818310* BLINKER CABLE CONNECTION

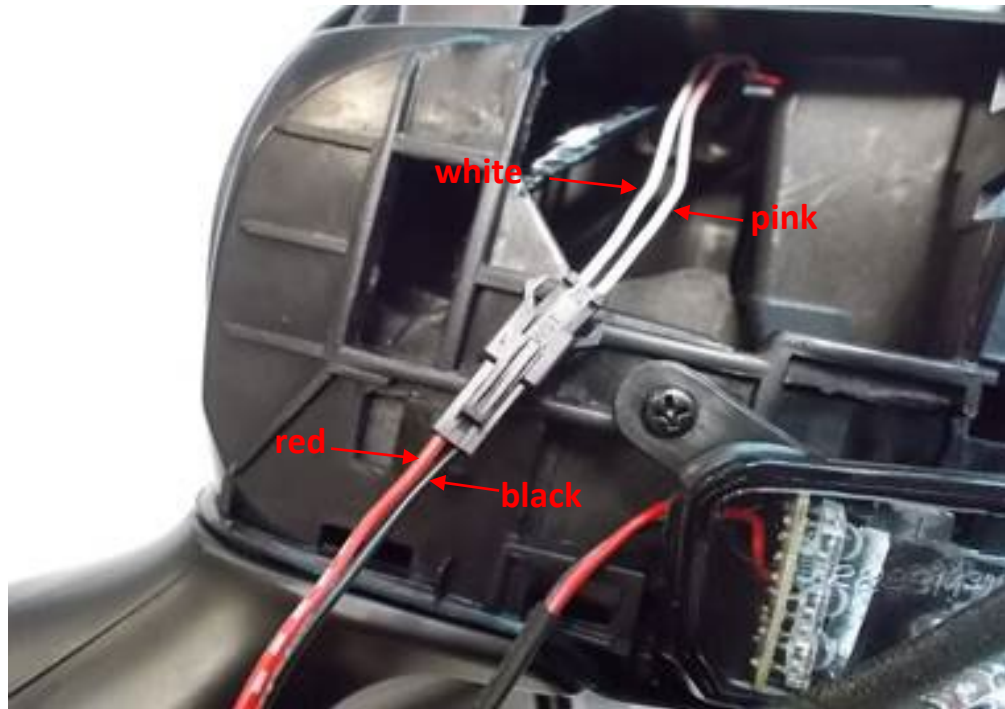
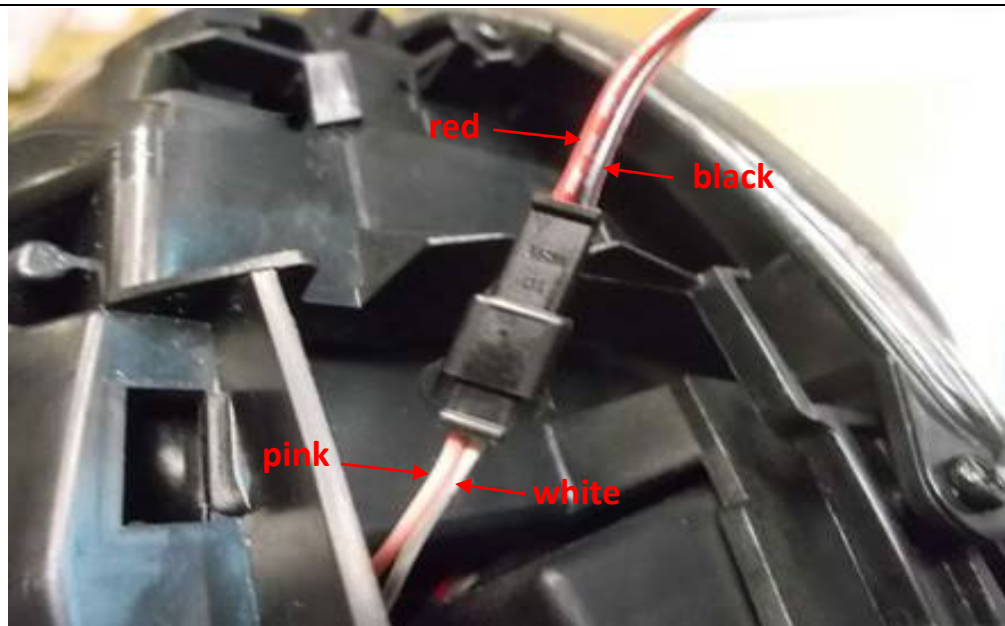
OLD VERSION: 81831041,81831042,81831043,81831044

Red ↔ White
Black ↔ Pink

NEW VERSION: 81831045,81831046,81831047,81831048

Red ↔ Pink
Black ↔ White
